CONSUMER PRODUCT SAFETY COMMISSION

Safety Standard for Adult Portable Bed Rails

ACTION: Notice of proposed rulemaking; notice of opportunity for oral presentation of comments.

- Section 8.4.5.4. Add the following proposed figures (Figure 4a and Figure 4b) for reference for Zone 3 test:

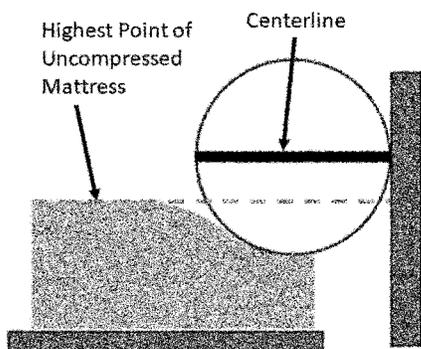
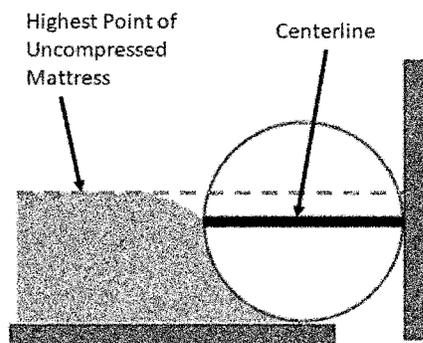
- Section 6.3.3: Zone 3—Revise “The highest point on the cylinder of the test probe (see 7.2) shall not pass completely below the horizontal uncompressed

plane of the mattress when tested according to 8.4.5.” Add at the end of the sentence “. . .when tested in accordance with section 8.4.5, the horizontal centerline on the face of the 4.7 in (120 mm) end of the test probe (see 7.2) shall be above the highest point of the uncompressed mattress.”

- Section 8.4.5.4: Revise “Turn the cone until the centerline on the face of the 4.7 in (119.38 mm) end is horizontal and let the cone sink into the space by its own weight. (1) If the line on the face of the 4.7 in (120 mm) end of the cone

is above the surface of the mattress highest point of the uncompressed mattress, as shown in Figure 4a, the space passes the test. (2) If the line on the face of the 4.7 in (120 mm) end of the cone is at or below the surface of the mattress, the space fails the test.” Instead of the “below the surface of the mattress” insert “below the highest point of the uncompressed mattress, as shown in Figure 4b.”

Figure 4a: Zone 3 Pass Criteria
(Centerline **above** highest point of uncompressed mattress)

Figure 4b: Zone 3 Fail Criteria
(Centerline **below** highest point of uncompressed mattress)

Figure 1 to paragraph (b)(14) of this section: Zone 3 test: (a) Pass, (b) Fail

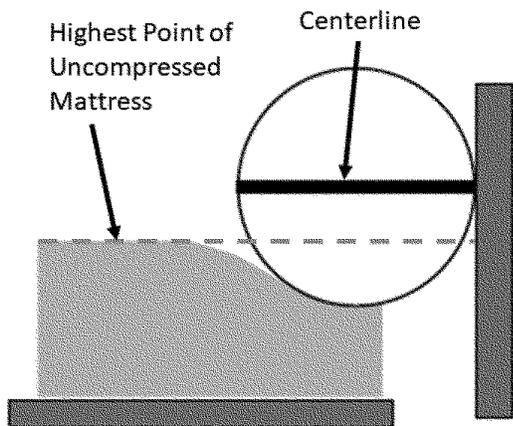
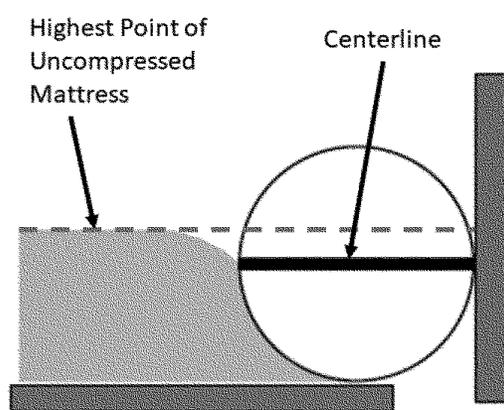
(A) If the line on the face of the 4.7 in (120 mm) end of the cone is above the highest point of the uncompressed mattress, as shown in Figure 1 to paragraph (b)(14) of this section, the space passes the test.

(B) If the line on the face of the 4.7 in (120 mm) end of the cone is at or below the highest point of the uncompressed mattress, as shown in Figure 1 to paragraph (b)(14) of this section, the space fails the test.

a: Zone 3 Pass Criteria
(Centerline above highest point of uncompressed mattress)

b: Zone 3 Fail Criteria
(Centerline below highest point of uncompressed mattress)
